Access Compliance Report

Public Rights-of-Way

Intersection ID: 30677	Main Street: DIXIE_HILLS_DR	Cross Street: MARVIN_RD	Location: NE
ADA ID: 12D046E7DB51	Ramp Type: BlendTrans2	Initial Pass/Fail: Fail	Overall Compliance: No
		Severity Score: 25

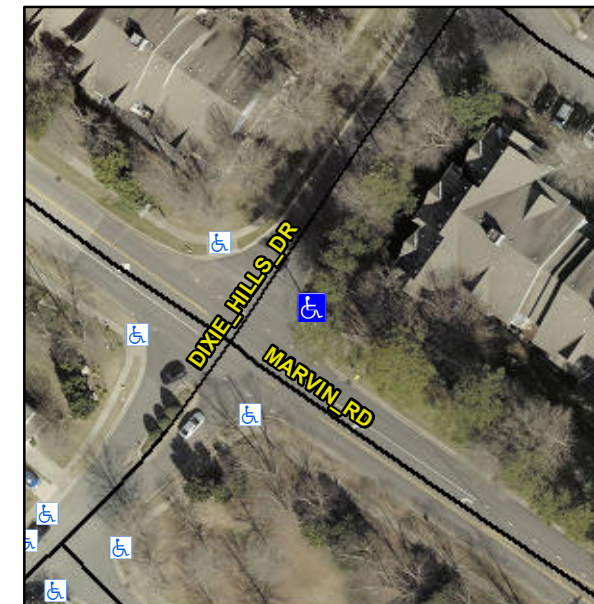
CURB LIP 2.0

R304.5.3

Compliance	Description	Data	Compliance	Description	Data
N/A	Ramp Length (in)	150.0	Yes	BlendTrans Slope (%)	2.5
Yes	Ramp Width (in)	58.0	No	BlendTrans XSlope (%)	7.0
N/A	Flare Type LT	N/A	N/A	Flare Type RT	N/A
N/A	Flare Slope LT (%)	N/A	N/A	Flare Slope RT (%)	N/A
N/A	Flare Traversable LT?	N/A	N/A	Flare Traversable RT?	N/A
N/A	Landing Length (in)	N/A	N/A	DWS Provided?	N/A
N/A	Landing Width (in)	N/A	N/A	DWS Contrast?	N/A
N/A	Landing Slope (%)	N/A	N/A	DWS Length (in)	N/A
N/A	Landing X Slope (%)	N/A	N/A	DWS Full Width?	N/A
N/A	Landing Curb? (Y/N)	N/A	N/A	DWS Offset (in)	N/A
N/A	Shared Landing?	N/A			
N/A	Gutter Ponding?	N/A	N/A	Gutter Slope (%)	N/A
N/A	Gutter Lip Ht (in)	N/A	N/A	Gutter X Slope (%)	N/A
N/A	Painted X Walk1?	No	N/A	Painted X Walk2?	No
	X Walk 1 Direction	To NW		X Walk 2 Direction	To SW
	X Walk 1 Width (in)	N/A		X Walk 2 Width (in)	N/A
	X Walk 1 Slope (%)	4.8		X Walk 2 Slope (%)	1.6
	X Walk 1 X Slope (%)	1.2		X Walk 2 X Slope (%)	5.5

Remove & Replace Curb Ramp With Two New Directional Ramps or Equivalent.
